Subject: Stagebarn Middle School

Re: **RFP 005 Add Masonry Back in at Admin Area**

PROPOSAL REQUEST

Description: Add masonry back in at Admin area

SD5 - PARTIAL FLOOR PLAN - AREA C
 SCALE: 1/8" = 1'-0"

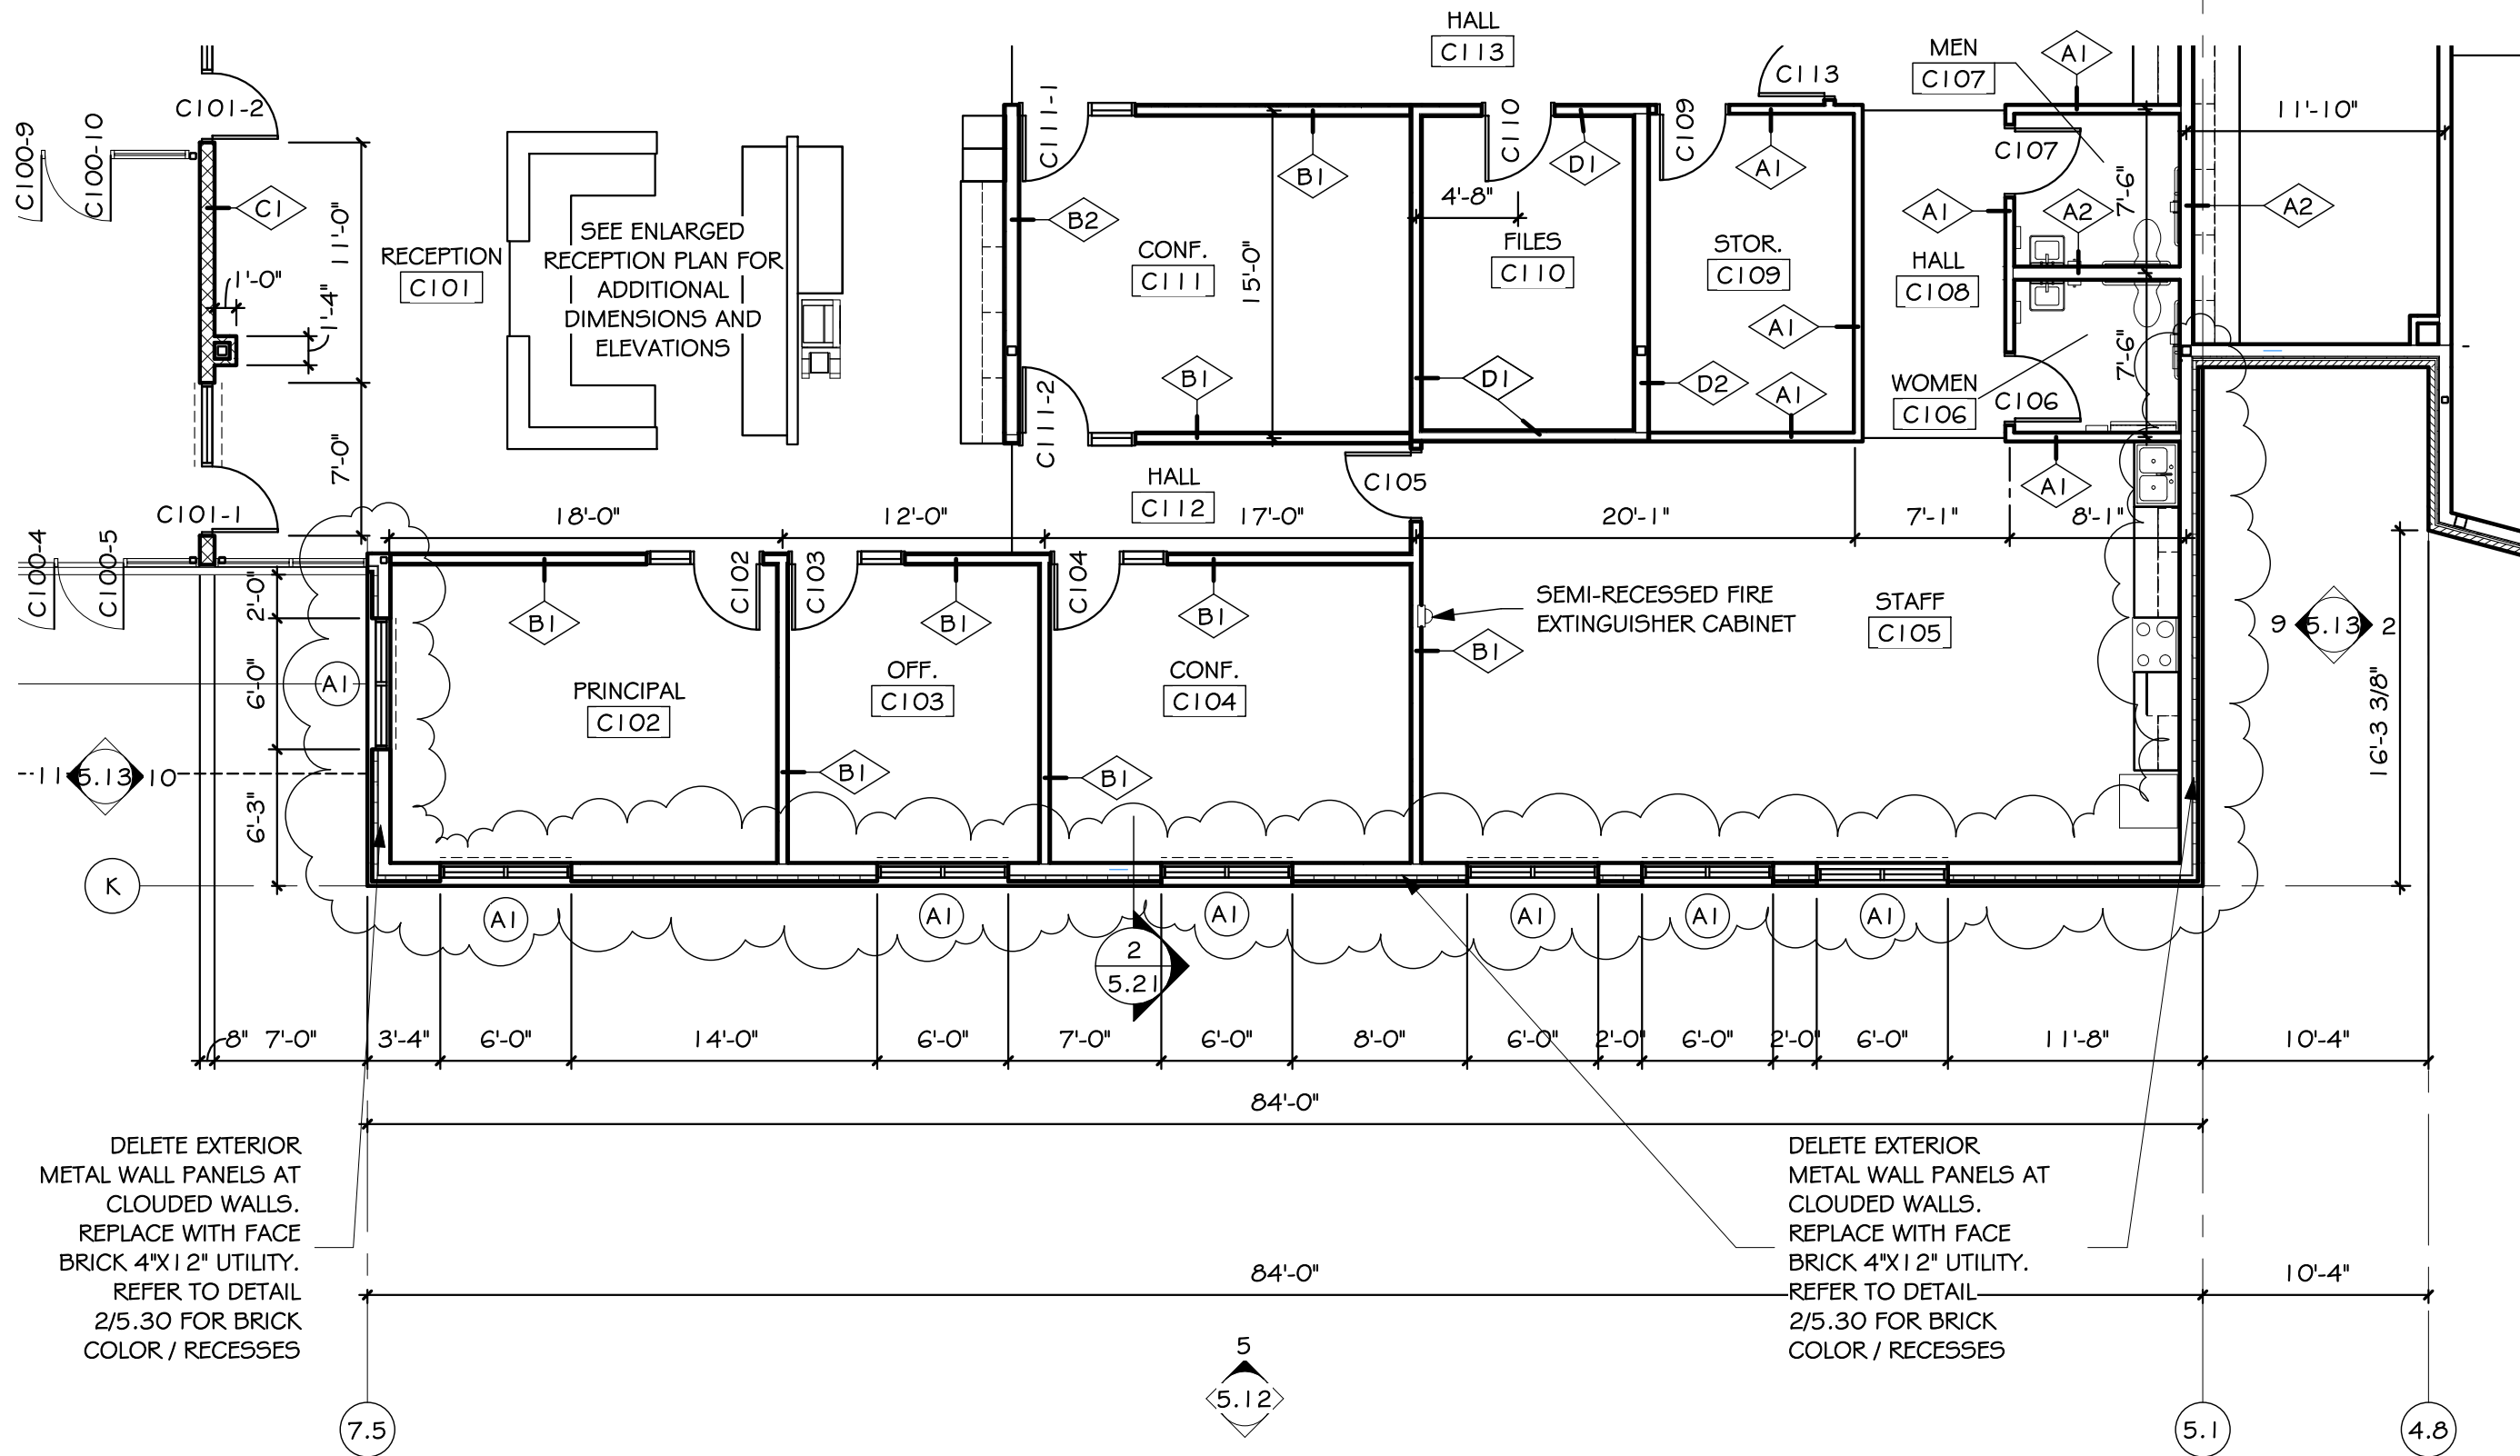
The owner has requested to add masonry back to the exterior walls of the administration area in Area C.

Delete exterior metal wall panels at clouded exterior walls as shown in (attached) Supplemental Drawing SD-5 dated 08.02.2017.

Add Face Brick 4"x12" utility at walls where metal wall panels were deleted. Refer to detail 2/5.30 for color and brick recess locations.

DELETE EXTERIOR METAL WALL PANELS AT CLOUDED WALLS. REPLACE WITH FACE BRICK 4"X1 2" UTILITY. REFER TO DETAIL 2/5.30 FOR BRICK COLOR / RECESSES

DELETE EXTERIOR METAL WALL PANELS AT CLOUDED WALLS. REPLACE WITH FACE BRICK 4"X1 2" UTILITY. REFER TO DETAIL 2/5.30 FOR BRICK COLOR / RECESSES
